2 June 2020

2190948

Response to Submissions
Channel 9 Site, Willoughby – MOD 4 to Concept Plan Approval MP10_0198

Figure 1 Comparison of existing/approved and proposed – Richmond Ave elevation

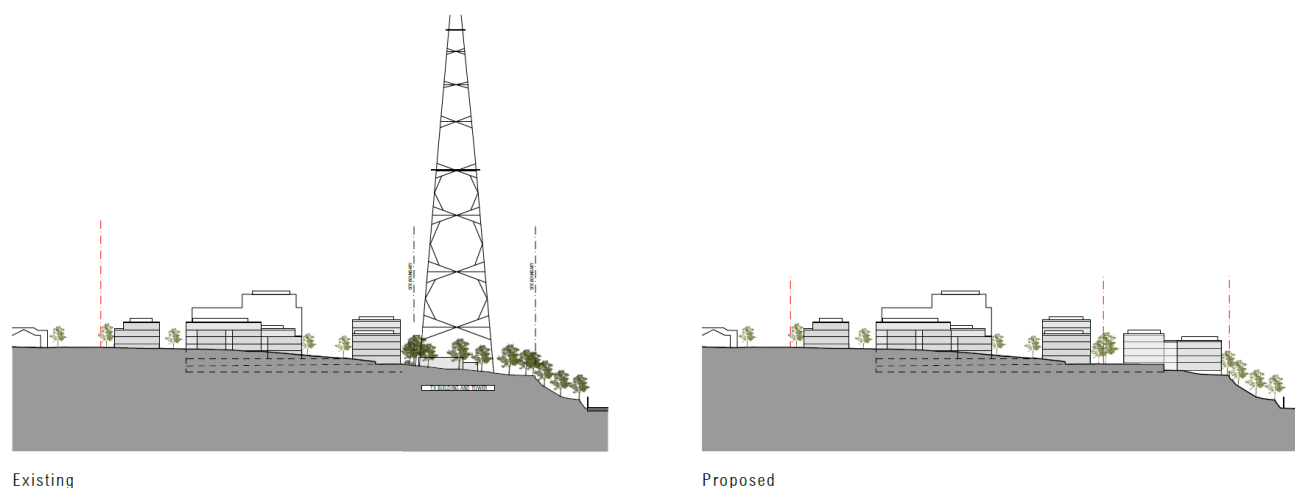
The proposed Building K is separated from the existing dwellings across Richmond Ave by a distance of 32-36 metres, being approximately 2-3 times the minimum separation between buildings of this scale required under the Apartment Design Guide. The proposed building height will not result in any adverse impacts in terms of visual privacy, overshadowing or views, and would remain entirely within the street scale and character established by approved Buildings A, C and H.

The proposed Building K envelope is well thought out and respectfully conceived by architects and urban designers Chrofi. It seeks to be consistent with the form and scale of buildings established under the existing Concept Approval along Richmond Avenue, notwithstanding the dominating height of the existing transmission tower in the existing streetscape. As illustrated in **Figure 1** (refer to **Attachment B** for further detail), the proposed Building K would result in a significantly less obtrusive built form that is in keeping with the adjacent approved building envelopes. **Figure 2** identifies how the height plane of the adjoining 4-storey 'bush building' - Building H – has been maintained, consistent with the approach taken to the relationship between Buildings A and C further to the north along the street where a similar change in levels also occurs. Whilst the existing street levels fall gradually towards the southern extent of Richmond Ave, maintaining the height datum of the bush buildings is an appropriate urban design response that will create a high-quality and legible streetscape.
